Class Permissive Change request letter

Model: SA-N9000

FCC ID: T8GSAN9000

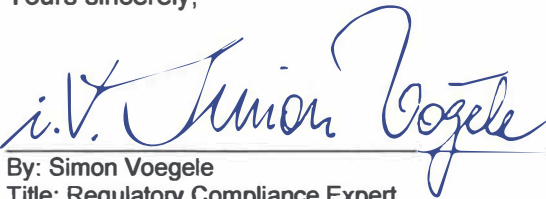
The main changes introduced in the device is:

- The hosts (WAVE-11-HIGH-R2 & WAVE-11-HAF-R2) where the module has been integrated together with another cellular module (FCC ID: SA-N9001) has some antennas located at less than 20 cm to the human body, and these antennas will make the device to work in portable conditions on these antennas.
